Access Compliance Report Public Rights-of-Way (Curb Ramps)

Main Street: MUMFORD_RD Cross Street: ARROYO_AVE Location: SW

ADA ID: RPRK211013115054 Ramp Type: Type 1 - Perpendicular Diagonal Initial Pass/Fail: Fail Overall Compliance: No Severity Score: 30

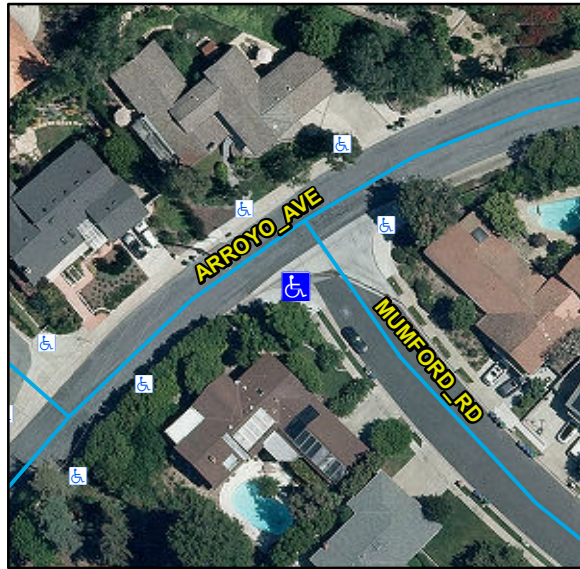
R304.2.2, R204.3, R304.5.3, STD 1115

Remove & Replace Curb Ramp With Two New Directional Ramps or Equivalent.
